Access Compliance Report

Public Rights-of-Way

Intersection ID: N/A	Main Street: POINDEXTER_DR	Cross Street: YOUNGBLOOD_ST	Location: N
ADA ID: 3B0D40ABC222	Ramp Type: Directional1	Initial Pass/Fail: Fail	Overall Compliance: No
		Severity Score: 12.5

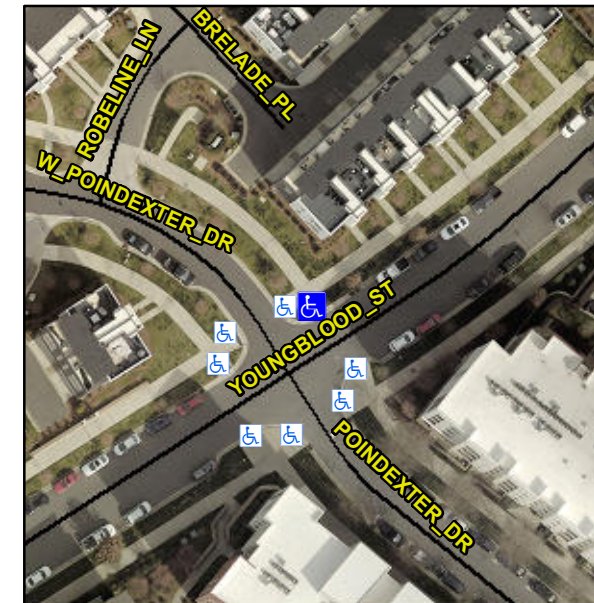
R304.2.2

Remove & Replace Entire Ramp.
